Improved Technical Specifications

LaSalle County Station

Volume 5:
Sections 3.4 and 3.5

ComEd

Figure 3.4.1.5-1

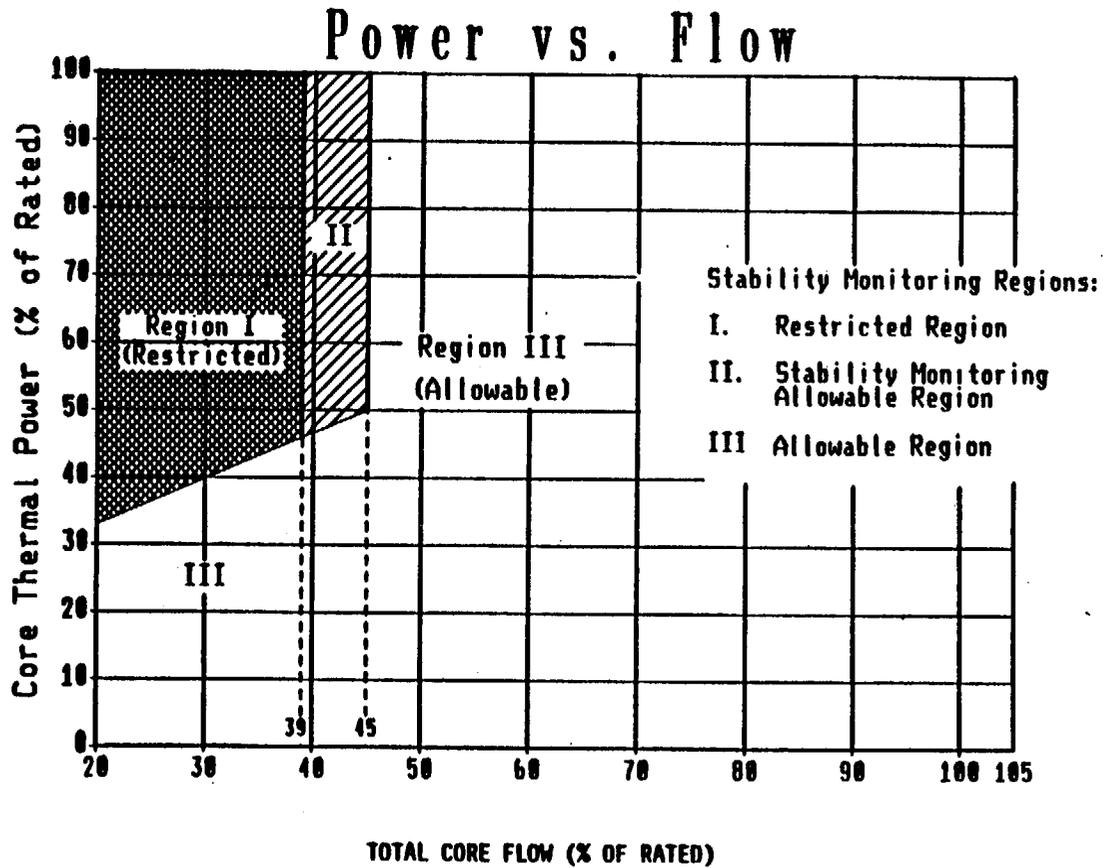
- A.8 CTS 3.4.1.5.a requires the total core flow to be $\geq 45\%$ of rated core flow during forced core circulation operation and CTS 3.4.1.5.b requires THERMAL POWER to be within Region III of CTS Figure 3.4.1.5-1 (ITS Figure 3.4.1-1). Only one of these two requirements has to be met. The CTS 3.4.1.5.a restriction has been deleted since it is sufficient to make reference to be in Region III of ITS Figure 3.4.1-1. Since this change deletes a duplicate requirement, the change is administrative.

- A.9 CTS 3.4.1.5 requires APRM and LRPM noise levels to be within limits when in Region II of Figure 3.4.1.5-1 (ITS Figure 3.4.1-1). Proposed ITS LCO 3.4.1 requires recirculation loop operation within Region III of Figure 3.4.1-1. When recirculation loop operation is within Region II of Figure 3.4.1-1 (CTS Figure 3.4.1.5-1), ITS 3.4.1 ACTION A provides requirements to verify APRM and LRPM noise levels are within limits. Also, CTS 4.4.1.5.2 requires verification that core flow is greater than 39% rated core flow with recirculation loop operation is within Region II of Figure 3.4.1.5-1. 39% rated core flow is the lowest flow limit of Region II. Operation less than 39% rated core flow when in Region II results in entry into Region I of Figure 3.4.1.5-1. As such, ITS 3.4.1 Required Action A.3 requires verification that operation is not within Region I of Figure 3.4.1-1. The proposed changes are only changes in presentation preference and do not alter the intent of the existing requirements. Therefore, the changes are administrative.

Figure 3.4.1-1 (page 1 of 1)
Power versus Flow

Figure 3.4.6.1-1a

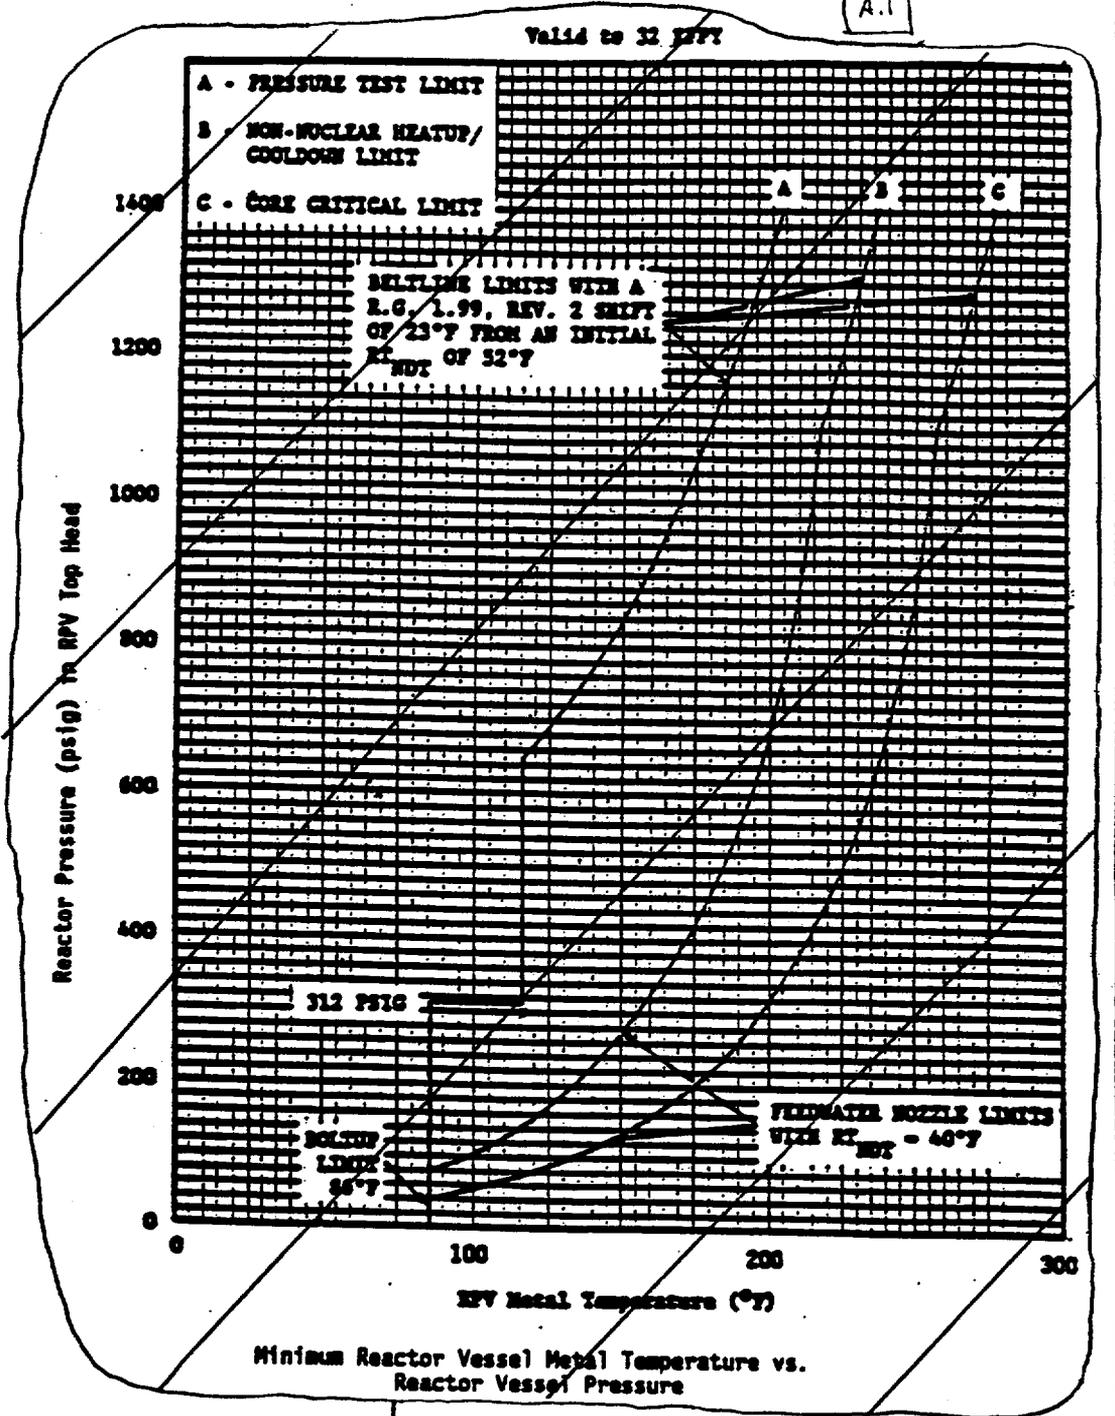
Replace with Figures 3.4.6.1-4, 3.4.6.1-5 and 3.4.6.1-6
3/4 4-19a
